Minutes of RSC Meeting**Meeting Held February 22, 1996**

Subject: E910 in the A1 Beam Line and MPS Area

To: Radiation Safety Committee
Subject: Positive beam in A1

CASIM Simulation of Al Shield

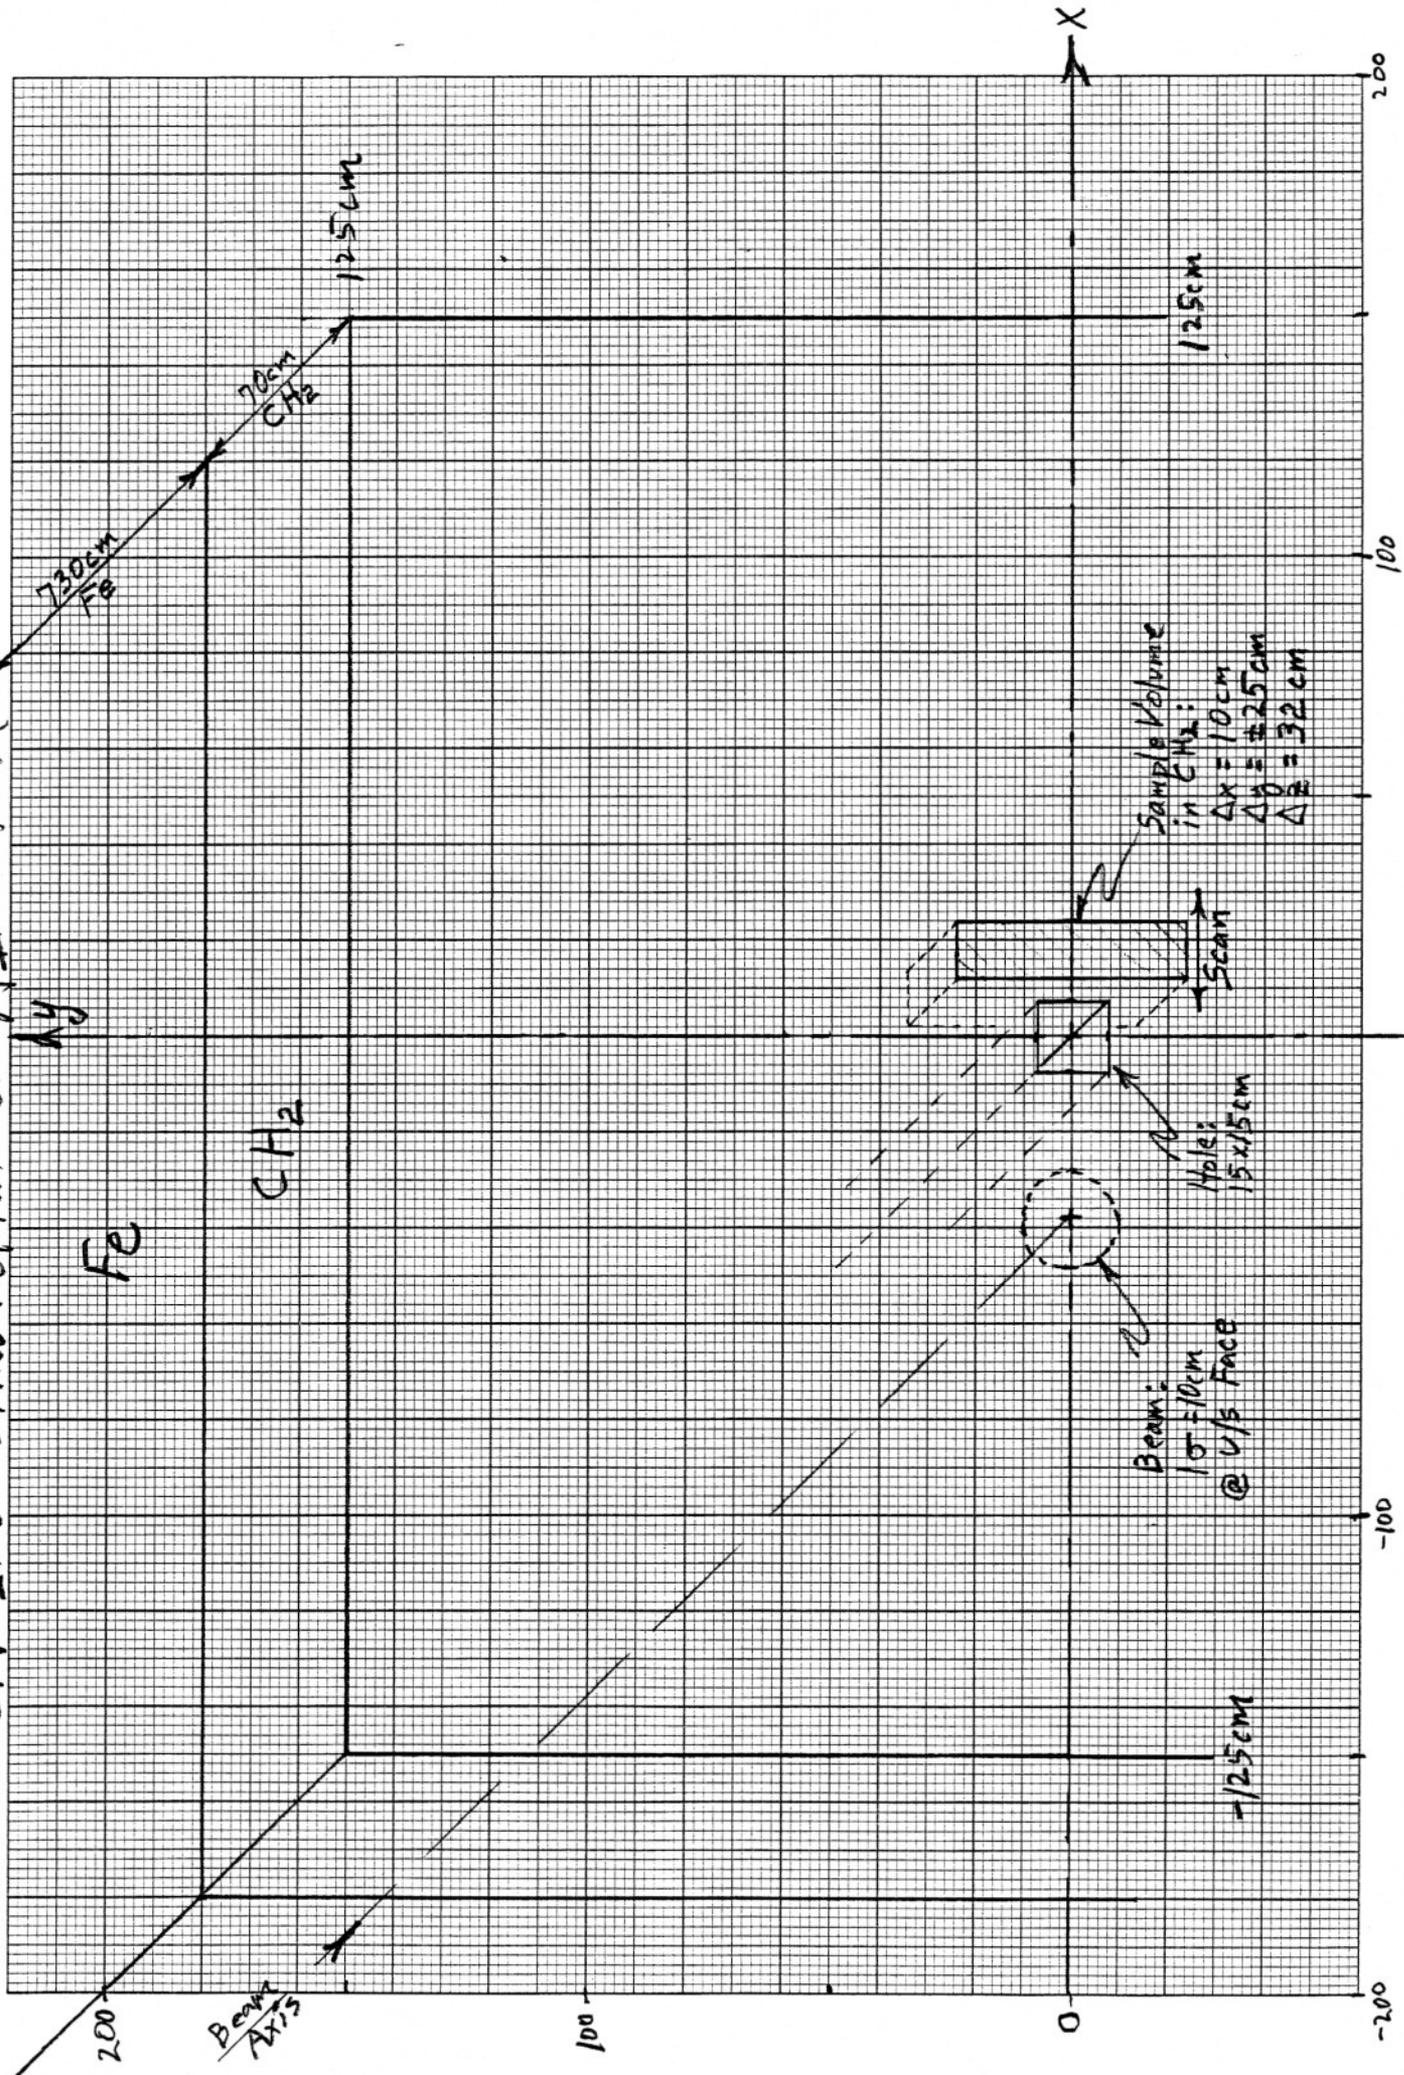
H. Brown presented some estimates of the radiation coming out of the beam pipe into the A1 primary cave which is caused by the primary beam cascade in the shielding next to the beam tube in the wall between the A cave and the A1 primary cave. Three cases were considered using CASIM. The proton beam has a 1 sigma size of 10 cm and 4 mradians. Dose equivalent rates are at the exit port in the A1 primary cave upstream of A1D5.

1. Proton beam 28 cm from beam port with angle of 0 mradians
7000 rem/hr/tp
2. Proton beam 28 cm from beam port with angle of 20 mradians
400 rem/hr/tp
3. Proton beam 38 cm from beam port with angle of 0 mradians
200 rem/hr/tp

Although these numbers are large, they are only over the area of the beam tube. There is substantial shielding at the downstream end of the A1 primary cave (8 feet of shielding) and the transport magnets provide additional shielding. Substantial reduction is also expected from the distance to the end of the A1 primary cave. Surveys should examine the penetrations to the A1 primary cave especially the A3 beam port into the E864 area for possible radiation levels.
